Hunter Street East Over Station Development

Submissions Report

January 2024

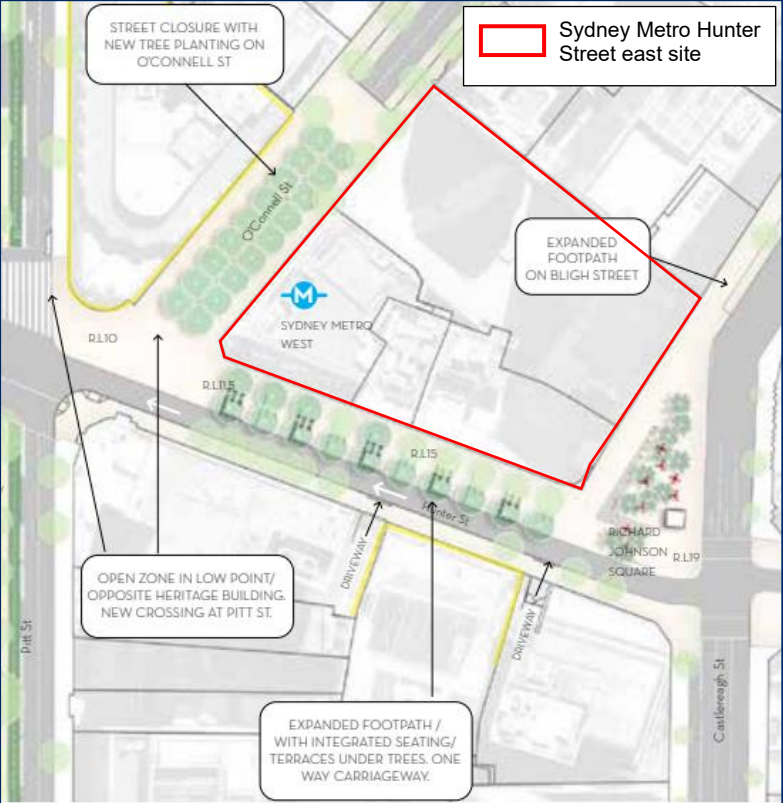
No.	Issued raised	Sydney Metro response
City of Sydney Council		
1. Interface with the public domain		
<p>1.1 City North Public Domain Plan</p>	<p>The City of Sydney advises that the Concept SSDA should refer to the City North Public Domain Plan. The Concept SSDA should reflect the current context with George Street north which is now closed to through traffic and Hunter Street is now closed just east of the George Street intersection. Additional pedestrian space around the site is a priority.</p>	<p>As outlined in Section 1.1, any public domain works on or adjacent to the site, including any footpath widening at the site, is within the scope of the Stage 3 CSSI Approval and is not impacted by the Concept SSDA for the OSD. Notwithstanding, the concept for the OSD including the proposed building envelope does not adversely impact the ability for the City of Sydney and Sydney Metro to collaborate to improve pedestrian space around the site.</p> <p>The EIS submitted with the Concept SSDA addressed the trial period closure of George Street between Hunter Street and Grosvenor/ Bridge Street to vehicular traffic from 09 January 2022.</p> <p>Since the public exhibition of the Concept SSDA, the City of Sydney adopted amendments to the City North Public Domain Plan which envisages the permanent closure of George Street to vehicular traffic at the intersection with Hunter Street. The adopted City North Public Domain Plan includes two options for public domain updates in the Hunter Street precinct. Option 1 for the Hunter Street precinct which envisions the extension of pedestrian priority along Hunter Street and the partial street closure along the southern portion of O'Connell Street, as shown in Figure 4-1. O'Connell Street to the north of the site would be converted to a two-way road, and Hunter Street would be proposed as a one-way, west bound road with additional landscaping and integrated seating immediately south of the site.</p> <p>Option 2, preferred by Sydney Metro to enable the metro station and OSD to operate most effectively, shown at Appendix C of the adopted City North Public Domain Plan includes a share zone along Hunter Street immediately south of the site as shown in Figure 4-2, along with the partial closure of O'Connell Street.</p> <p>The podium built form (which directly interfaces with the proposed changes to O'Connell and Hunter Streets) will be constructed under</p>

No.	Issued raised	Sydney Metro response
		<p>the Stage 3 CSSI Approval. The Concept SSDA for the OSD however makes provision in the reference scheme for future retail uses at ground floor and mezzanine level fronting Hunter Street and at the corner of O'Connell Street. The provision of retail uses, station and building entries on the ground level will positively contribute to the activation of the public domain and support the pedestrianization of Hunter Street and portions of O'Connell Street.</p>  <p>Figure 4-1 City North Public Domain Plan Extract (Option 1)</p>
